ND-2013-0002
January 11, 2013

Subject: **PSEG Early Site Permit Application**
Docket No. 52-043
Response to Request for Additional Information, RAI No. 61, Vibratory
Ground Motion

Response to RAI No. 61

02.05.02-10, SRP Section: 02.05.02 – Vibratory Ground Motion

FIGURE RAI-061-10-67

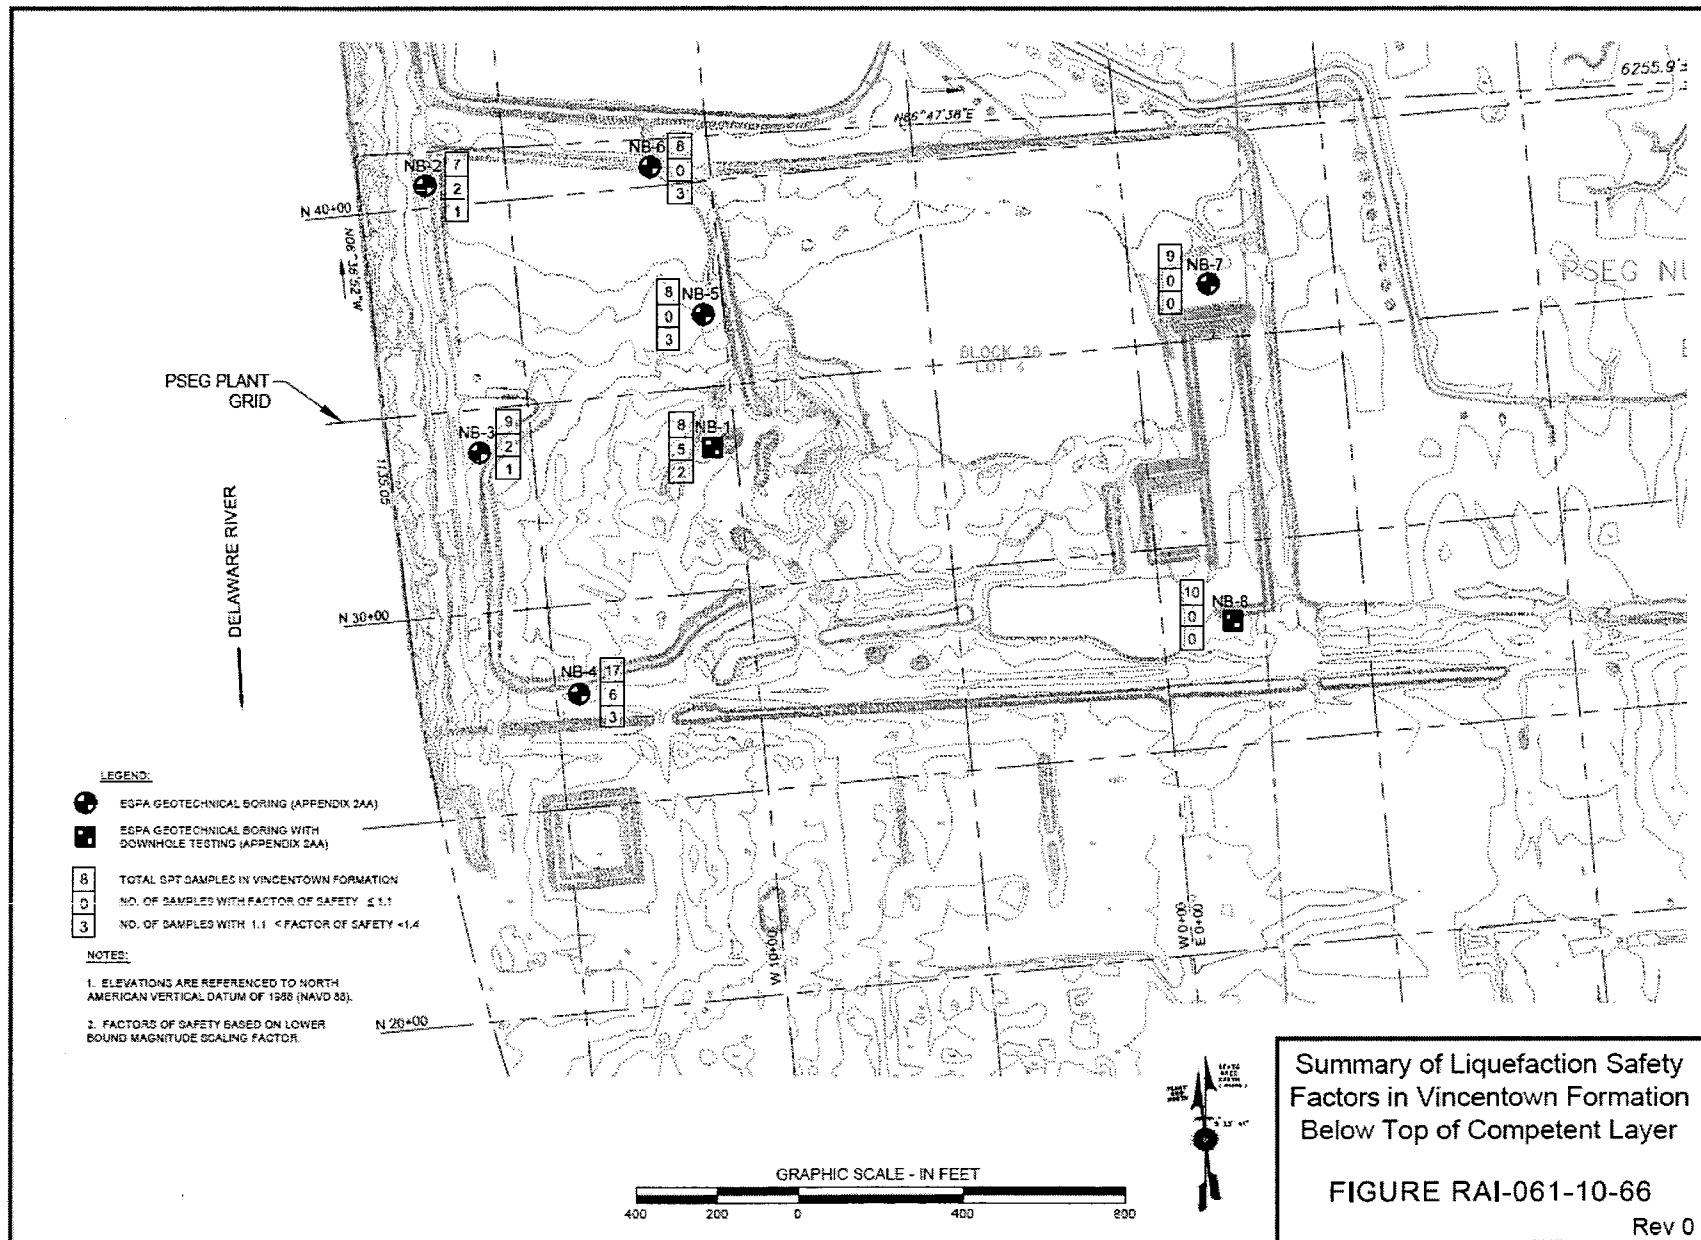
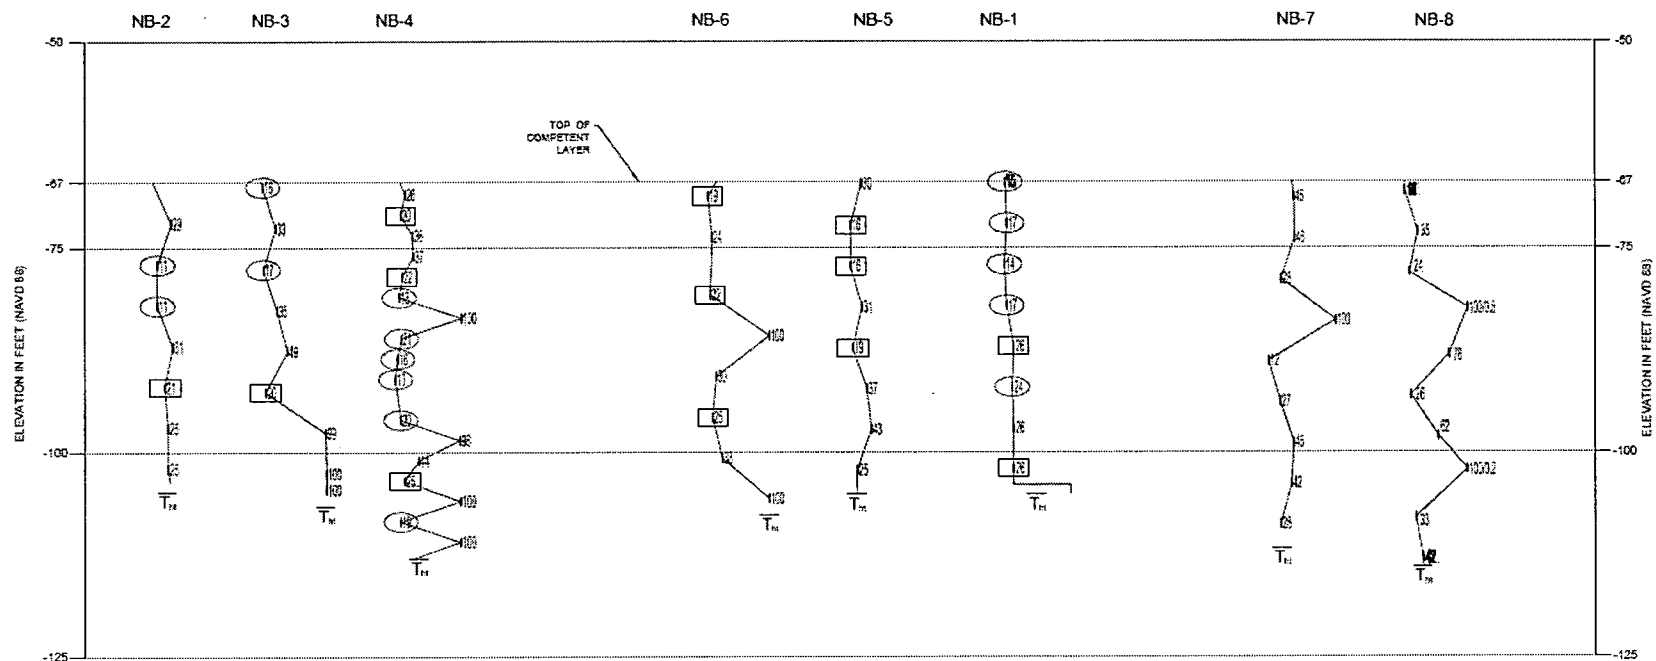
a) Evaluate the potential impacts of the newly released CEUS-SSC model, with potential local and regional refinements as identified in the CEUS-SSC model, on the seismic hazard curves and the site-specific ground motion response spectra (GMRS). For re-calculation of the PSHA, please follow either the cumulative absolute velocity (CAV) filter or minimum magnitude specifications outlined in Attachment 1 to Seismic Enclosure 1 of the March 12, 2012, letter "Request for information pursuant to title 10 of the Code of Federal Regulations 50.54(f) regarding recommendations 2.1, 2.3, and 9.3, of the near-term task force review of insights from the Fukushima Dai-ichi accident." (ML12053A340)

Reference 6, the value of GMRS at 100 Hz using the CEUS-SSC (NUREG-2115) is 0.225g, which is greater than the value presented in existing Subsection 2.5.4.8.3 (0.18g). Calculation 360-RAI-061-10 examines the effect of the higher input acceleration on the calculated factors of safety against liquefaction (Reference RAI-61-10-13).

The results of the calculation, summarized in Table RAI-61-10-14, show an increase in the numbers of samples with factors of safety less than or equal to 1.1 from 3 to 17, and an increase in the numbers of samples with factors of safety greater than 1.1 but less than 1.4 from 9 to 15. The total number of samples reviewed is 257. Distribution of the samples with low factors of safety within the Vincentown Formation, the formation at and below the level of the competent layer, is illustrated on Figures RAI-61-10-66 and RAI-61-10-67. The SPT-based screening calculation results indicate the potentially liquefiable soils in the Vincentown Formation are isolated zones surrounded by denser materials, not a continuous layer.
